ALAMEDA COUNTY
HEALTH CARE SERVICES

Subject: Fuel Leak Case RO0000304, Dublin Auto Wash, 7240 Dublin Blvd.,
Dublin, CA 94568

Alameda County Environmental Health (ACEH) staff has reviewed the file for the subject site including the August 11, 2006 Site Investigation Report prepared by Pangea Environmental Services, Inc. This report provides the results of the previously approved work plan. The wide scope of work included the installation of borings SB-1 and SB-1A to investigate a sanitary sewer line adjacent to the site, the installation of soil boring SB-2 to investigate contamination southwest of the source, the destruction of wells MW-3, EA-1, EA-2 and EA-3 to eliminate potential vertical migration of contamination due to the long screened wells and the installation of a total of fourteen (14) wells to monitor the lateral and vertical distribution of contamination. Pangea also performed vacuum extraction from wells MW-3A and MW-7AA to evaluate the effectiveness of this source removal technique. The report findings include the following observations:

Figure 3: Proposed Location of CPTs and Soil Borings.

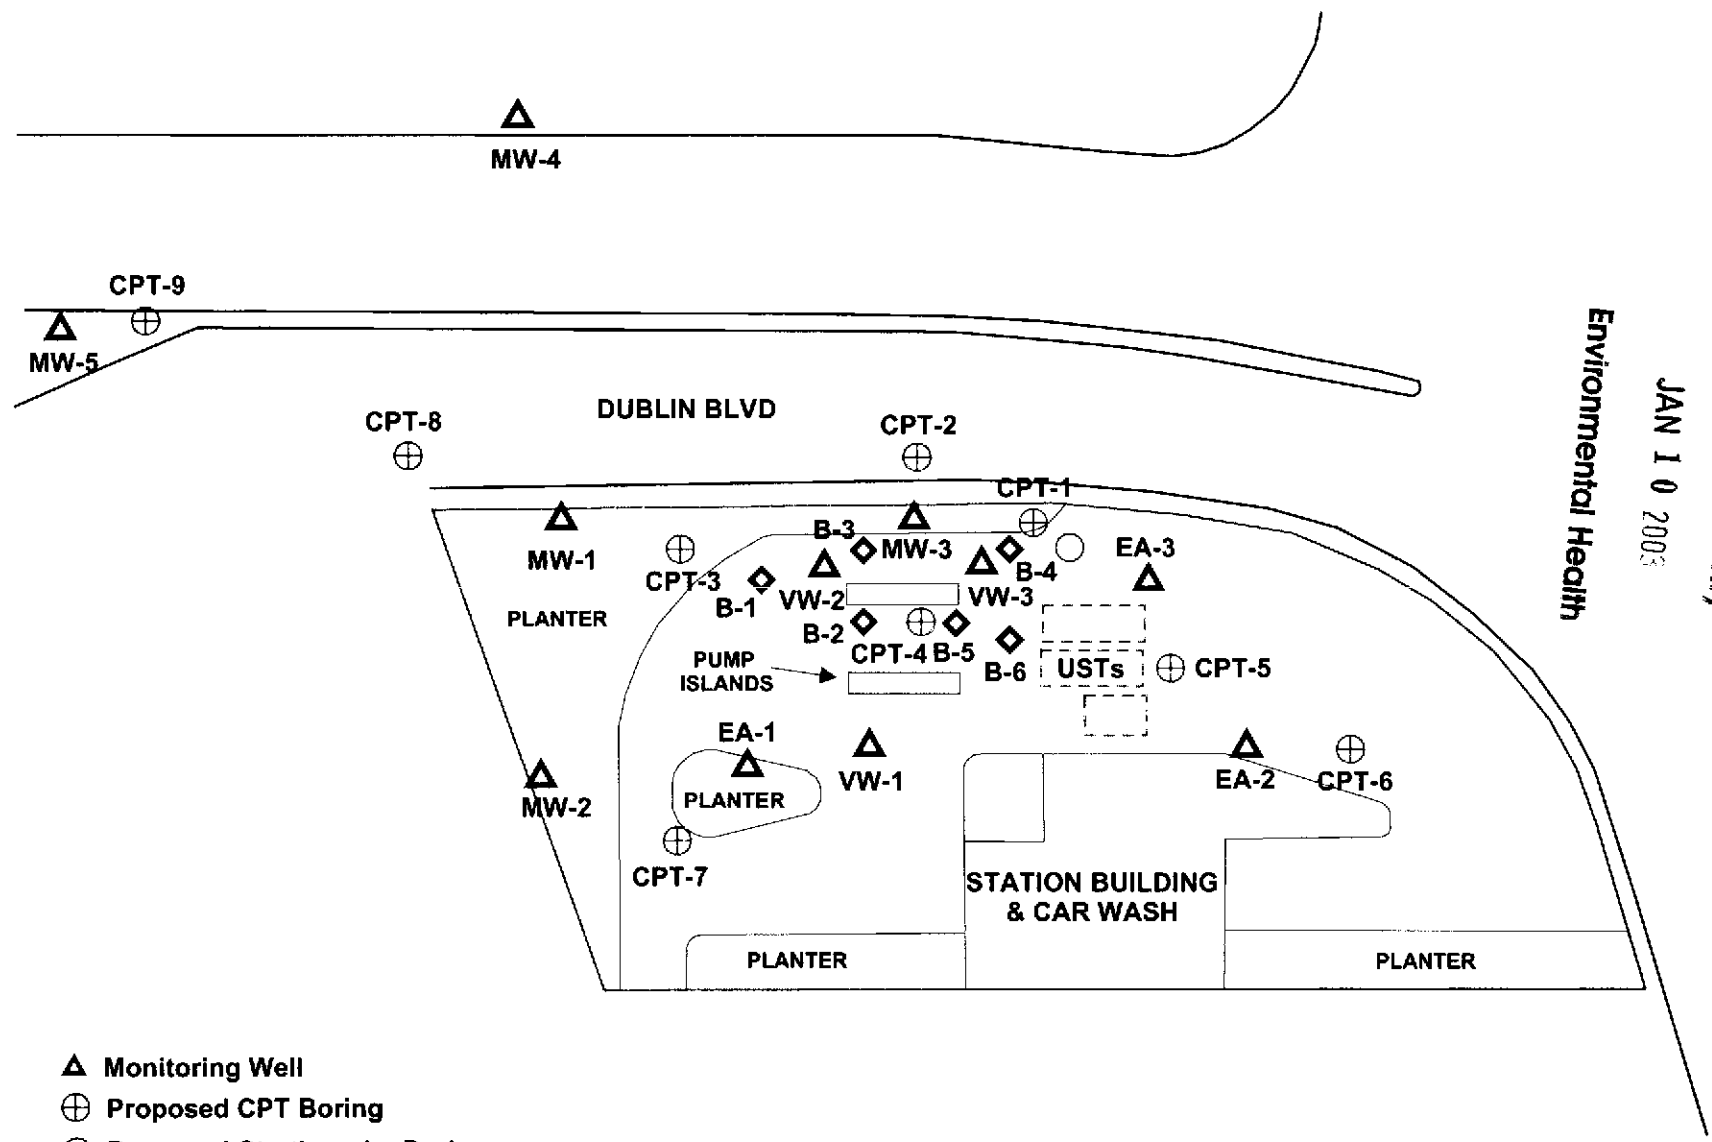
Per our telephone discussion, enclosed is the revised Figure 3 showing the location of three additional Cone Penetrometer Test (CPT) holes. As we discussed, the data generated during installation of CPTs should be sufficient to address the site's hydrogeology and extent of chemical plumes in the soil and groundwater. Thank you very much for your input and looking forward to working with you on this project.

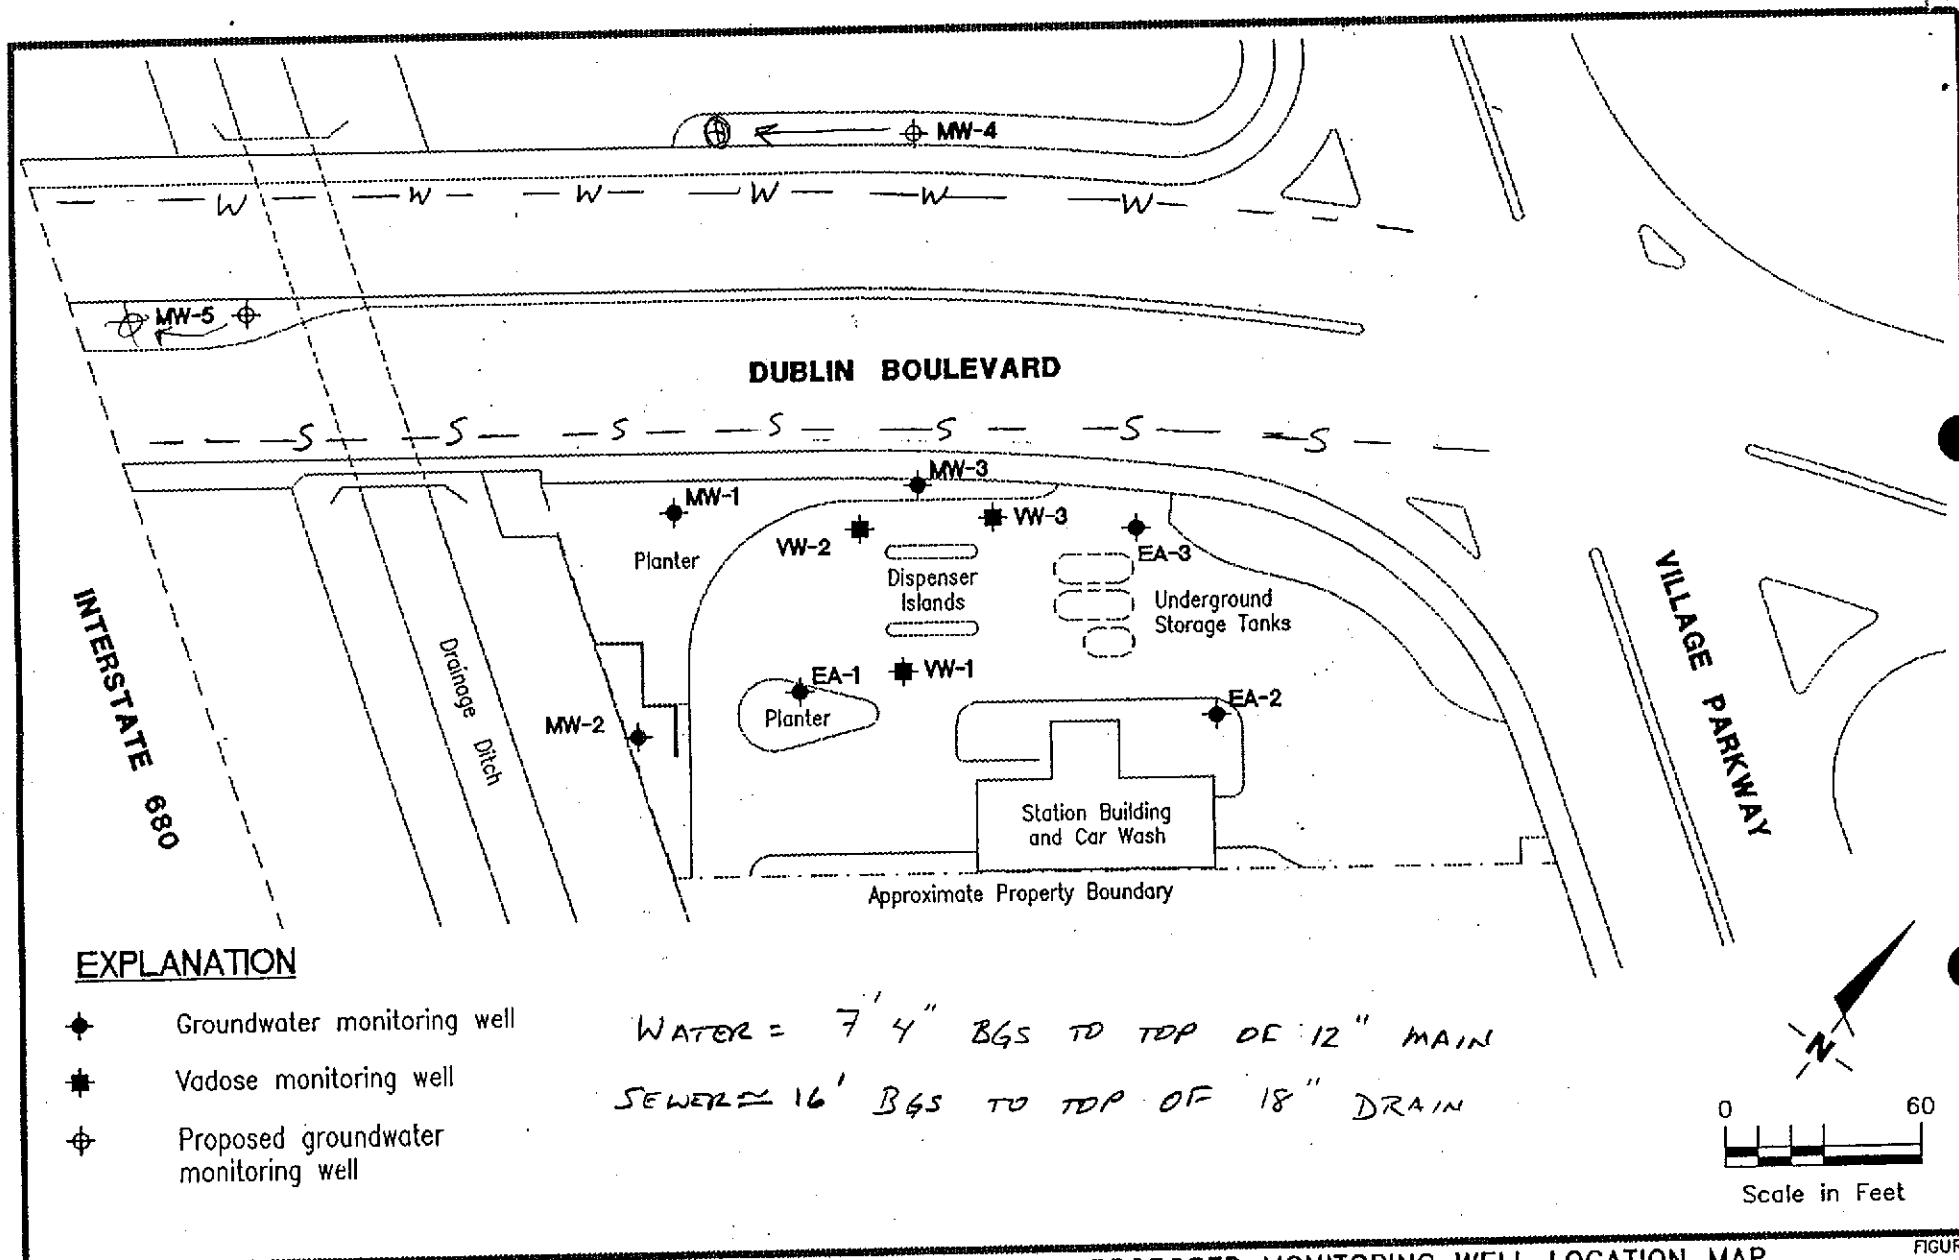
As we discussed on October 16, the proposed well location of MW-4 will be moved approximately 65 feet towards the entrance of the McDonald's driveway. The new location now places proposed wells MW-4 and MW-5 approximately 150 feet apart, as you requested.
